Staff Presentation to the
Portland Design Commission

Design Review Hearing
LU 15-251943 DZ
Grant Park Village II

February 4, 2016

Private Drive Ground Floor Uses

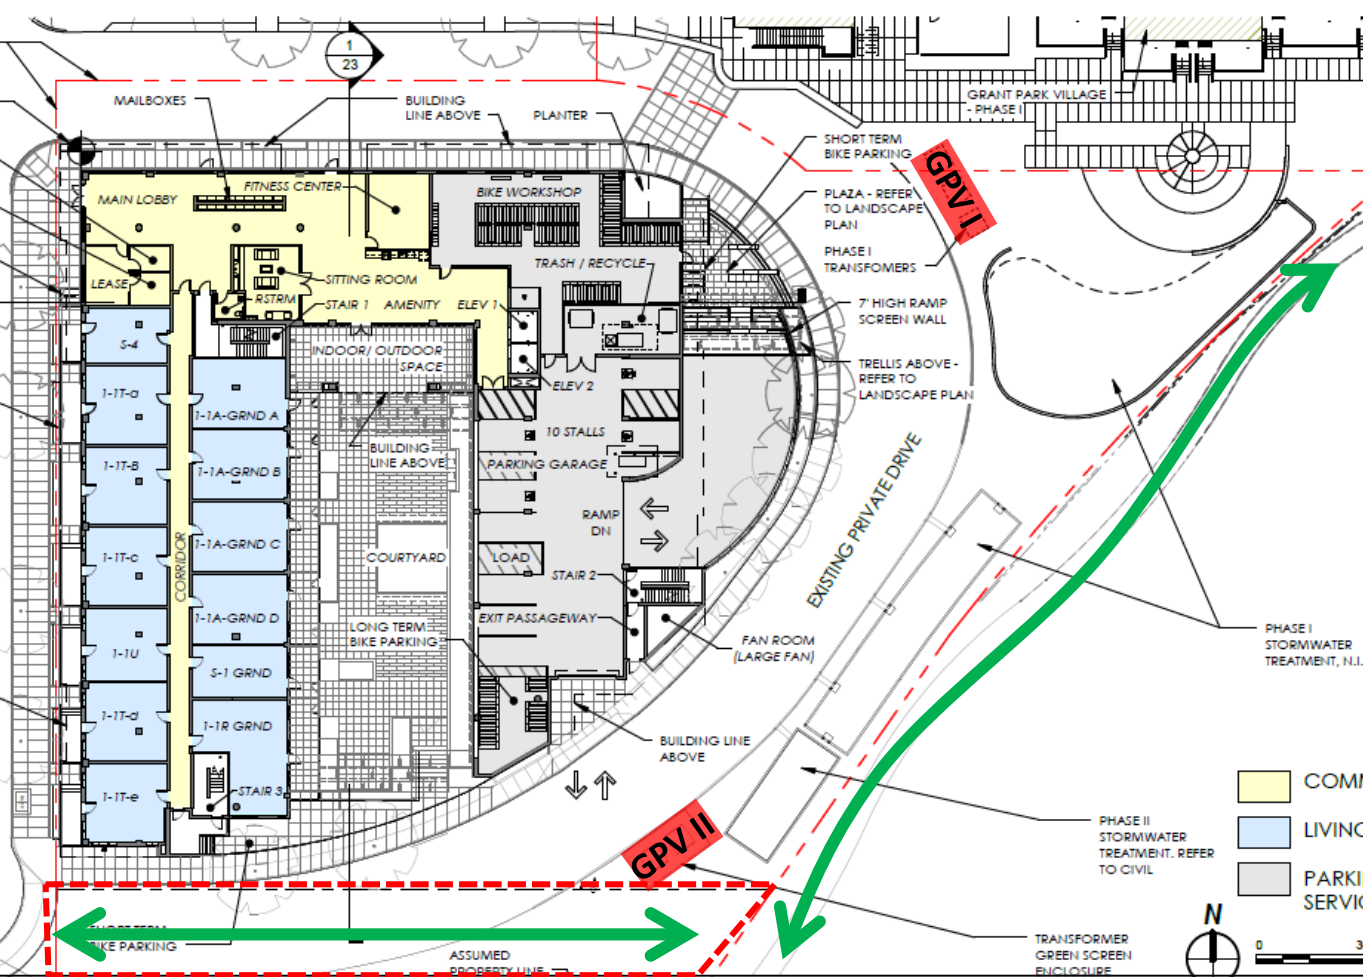
More active ground floor use is needed on the east elevation – residential, community space, bike lounge, etc. – creating an “active bar” on both sides of the plaza. Vehicular access should be limited to one side only – north or south. An applied exterior material solution and/or landscaping solution alone will not meet these guidelines.

Transformer Location

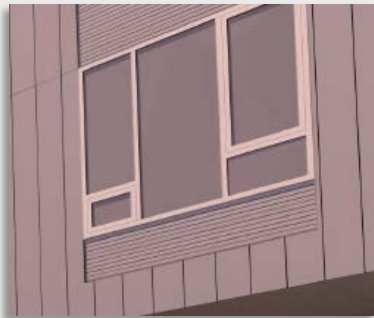
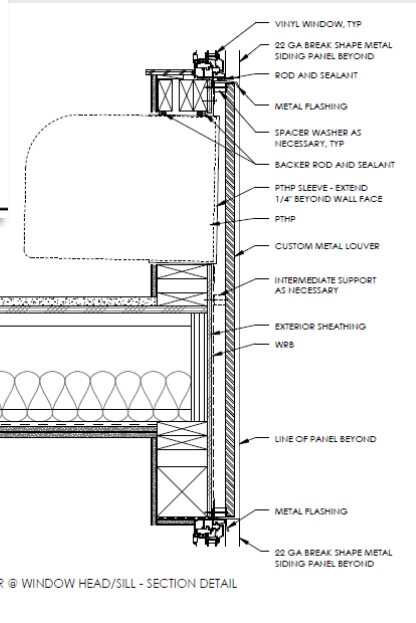
Given the precedent of Grant Park Village Phase I, Staff has significant concerns about the proposed pad mounted transformers adjacent to the Sullivan's Gulch Access Easement.

PTAC Grilles

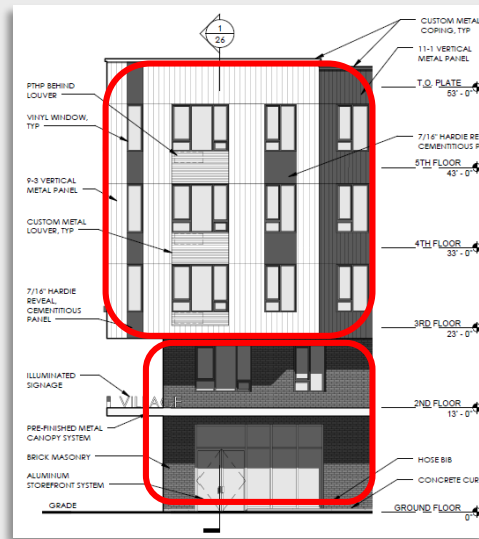
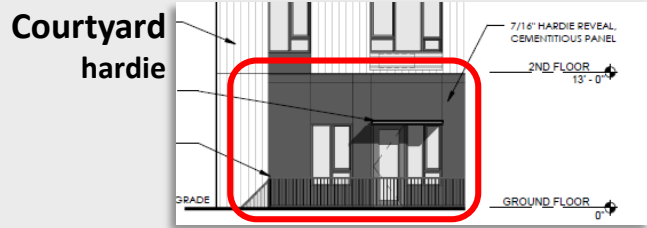
Given the precedent of Grant Park Village I, Staff has significant concerns about the PTAC louver / AC port details and has advised the Applicant provide a mock-up of the custom louver system at the hearing.

Windows and Materials

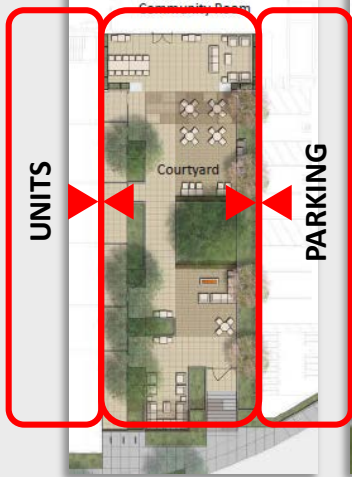
Specifications, details and samples for all proposed cladding materials are required. Staff has advised that (1) preferred primary cladding materials are concrete, cement plaster and brick; not metal, (2) better resolution of base details on all sides, with stucco and/or wood on upper levels and (3) ample balconies should be provided on all elevations (east-facing over the public space is critical).
